# *TPS EXPRESS NEWSLETTER*

### **07-01 Type Equipment Code (TEC).**

### **07-02 ATS Source Data Repository (ASDR)**

### **07-03 Unique Identification (UID)**

**ATTACHMENT 2, PERFORMANCE SPECIFICATION ADDENDUM for the Intermediate Level Test Program Sets (TPS)/Operational Test Program Sets (OTPSs) replace the existing paragraph Figure 1. Sample UID Label with the following:**

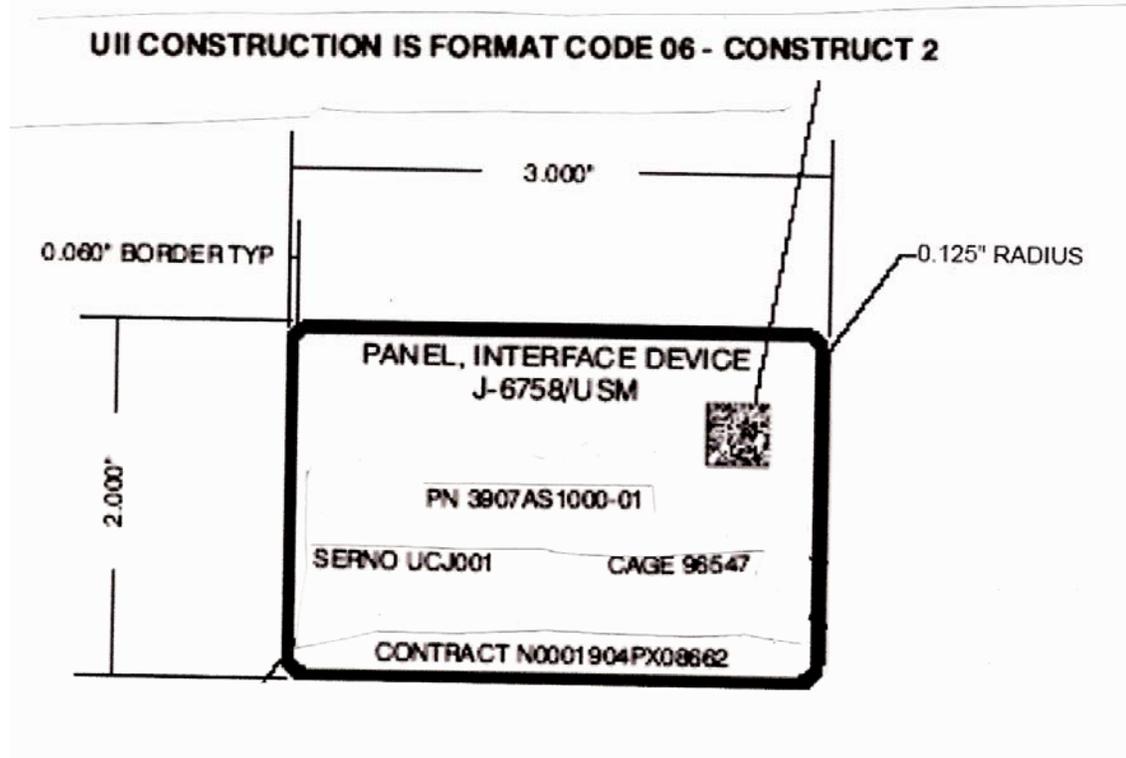
3.20.2. UID Location and Marking. The locations and marking methods selected shall bear no impact on the performance of the part and minimal configuration change(s) to the part. The UID (including 2D Matrix) should be incorporated onto the data plate. If the 2D matrix can't be incorporated onto the data plate, a 2D matrix sticker can be applied onto the main data plate provided it can be done without covering any critical data.

3.20 Item Unique Identification (IUID) Marking of US Military Property. In accordance with DFARS Clause 252.211-7003 Item Identification and valuation, the contractor is required to mark and register all end items and their components meeting the requirements called out in MIL-STD-130M. These include components for which the Governments unit acquisition cost is \$5,000 or greater, or any component, subassembly or embedded part that is serially managed, mission essential or a controlled inventory item.

3.20.1 Construct and Method. Details on creating the UID and the marking method are contained in MIL-STD-130M. Construct # 2 shall be the identification method utilized for the UID.

3.20.3 Permanency and Legibility. The UID marking and identification plates, tags, or labels when used on equipment, parts, assemblies, subassemblies, units, sets, or groups shall be permanent during the normal life expectancy of the item and be capable of withstanding the environmental test and cleaning procedures specified for the item. Legibility shall be as required for ready readability as per MIL-STD-130.

3.20.4 UID Registration. The prime contractor has the responsibility to furnish Item Unique Identification (IUID) data to the IUID registry. Data submission of IUID data and acquisition cost should be via Wide Area Work Flow (WAWF), IUID XML file, IUID flat file or web entry. Additional information regarding data submission as well as the actual marking can be found at <<http://www.acq.osd.mil/dpap/IUID/>>.

3.20.5 Records. The contractor shall maintain an accurate, current list of UIDs for all manufactured items on this contract and supply to the government upon request. The list shall include P/N, Serial #, CAGE, UID Location, Construct # 2, how it was marked and the registration method used.
